Delegated Report

Prior Approval Extensions Application

Application no:	20231199
Location	44 Northridge Road Gravesend Kent DA12 5AY
Proposal:	Prior approval application for a single storey rear extension with a depth of 5.8 metres, maximum height of 3.00 metres and eaves height of 2.60 metres.
Applicant:	Mr Joel Dix
Site Visit	N/A Desktop Assessment

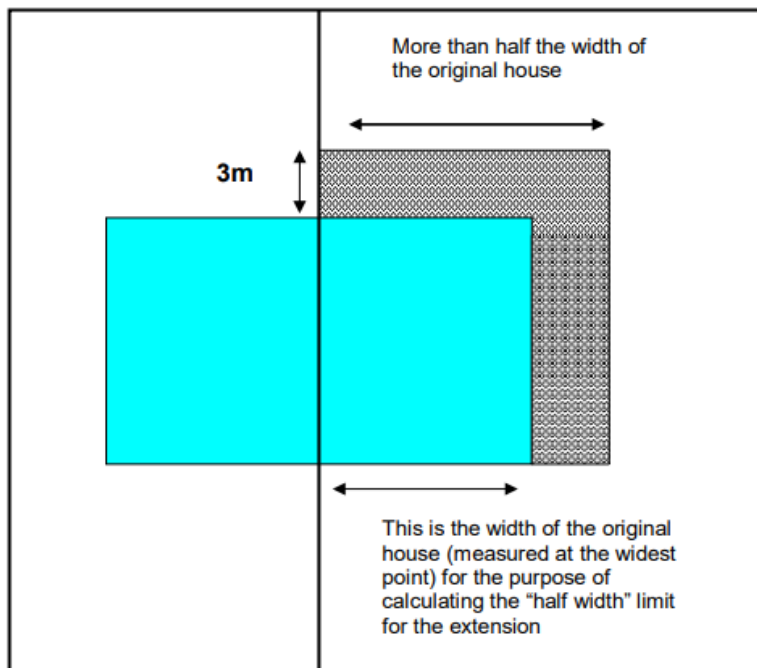
The proposed plans show the proposal would fail to comply with A.1 (j) (iii) as the total enlargement would extend beyond a wall forming a side elevation of the original dwellinghouse and have a width greater than half the width of the original dwelling. This is demonstrated visually below in the Government Technical guidance:

The information provided, shows the proposed development fails under Class A.1 (j) (iii), as the development would extend beyond a wall forming a side elevation of the original dwellinghouse and have a width greater than half the width of the original dwelling.

The proposed development does not comply with Class A.1 (j) (iii) of **THE TOWN AND COUNTRY PLANNING (GENERAL PERMITTED DEVELOPMENT) (ENGLAND) ORDER 2015, AS AMENDED**, and it is considered **PRIOR APPROVAL IS REQUIRED AND REFUSED**
